# Planning Commission Staff Report

MASTER PLAN AMENDMENT CASE NUMBER: WMPA21-0002 (Village Green Commerce Center Specific Plan)

BRIEF SUMMARY OF REQUEST: To amend selected development standards for the existing Village Green Commerce Center Specific Plan

Figure D-6 5: Buffering Yard Planting Plan

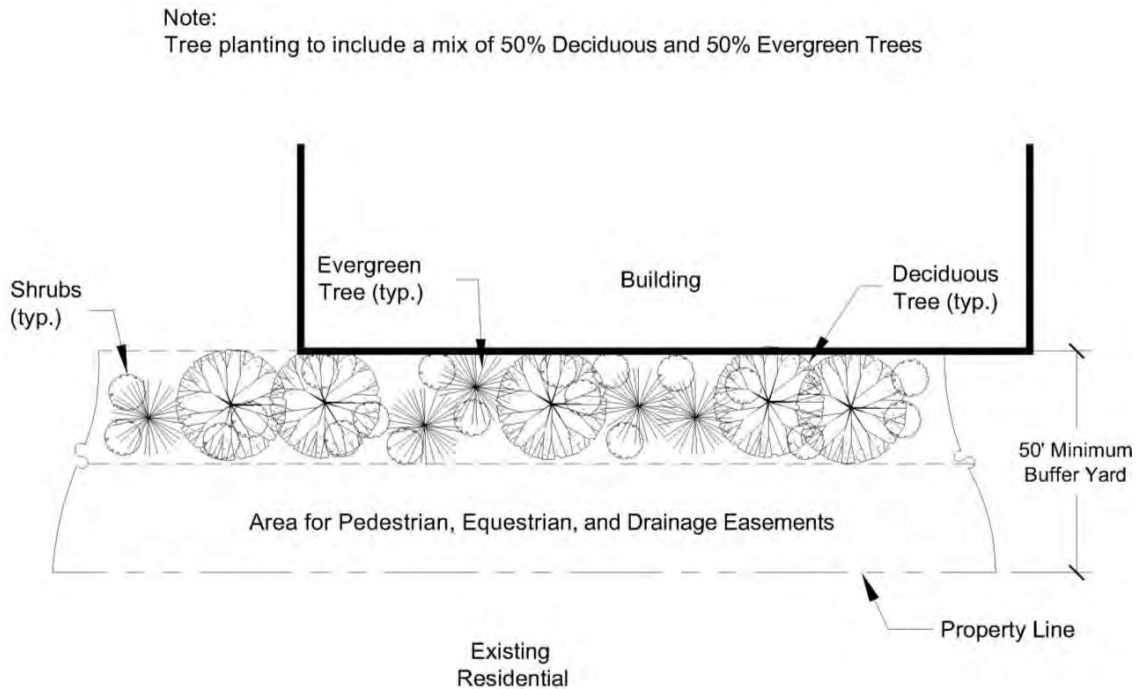
8. Clarify that no loading docks are allowed to be adjacent to residential property;
9. Remove Figure D-5: Business Park Buffering;
10. APN: 534-561-10 is exempted from Low Impact Development (LID) Standards and Environmental Sustainability Standards;

- Figure D-5: Business Park Buffering has been removed since the path name has changed to public trail easement and the location has changed to the west side of parcel 534-561-10;

**Landscape Screening** - Landscaping shall be provided at a rate of 50% evergreen trees and 50% deciduous trees with a planting density that is required by the development code for the buffer areas (See Figure D-6 5— Buffer Yard Planting Plan). The intent of the planting density is to provide a reasonable screening of all buildings along these property lines and soften the impact of building mass. It shall be the discretion of the landscape architect to determine the location of plant material, and selection of plant material with emphasis on reducing the visual impact of building mass.

**Figure D-7 6: Turf Areas**

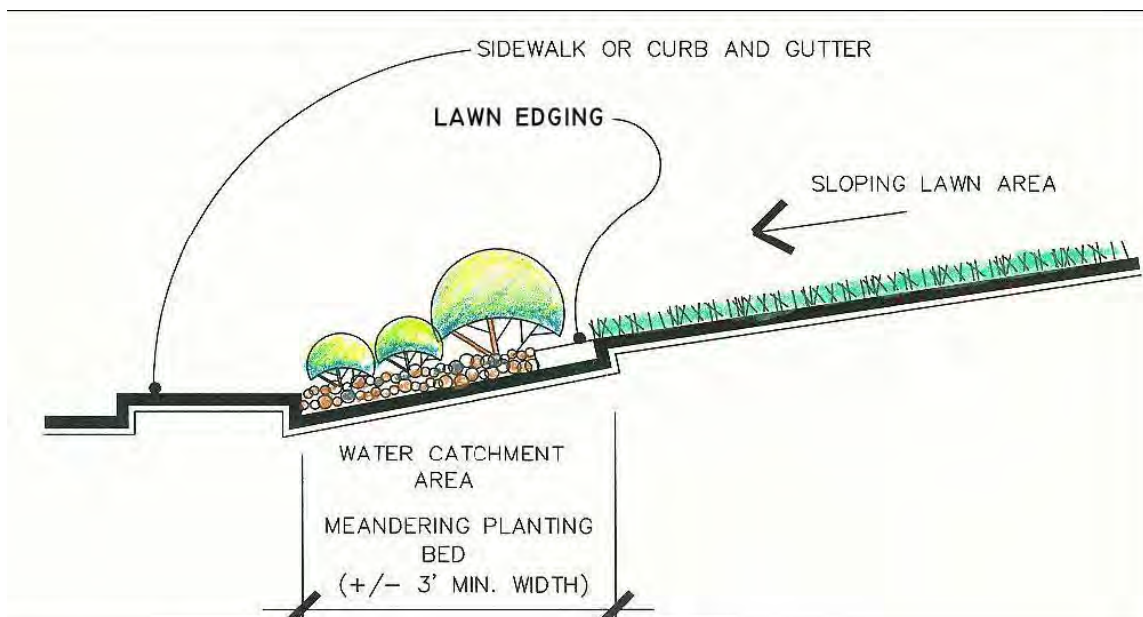
**Turf Areas:** A “water catchment area” or a planting bed shall separate lawn areas from hard surfaces such as streets and sidewalks in order to catch runoff (see Figure D-7 6 below).
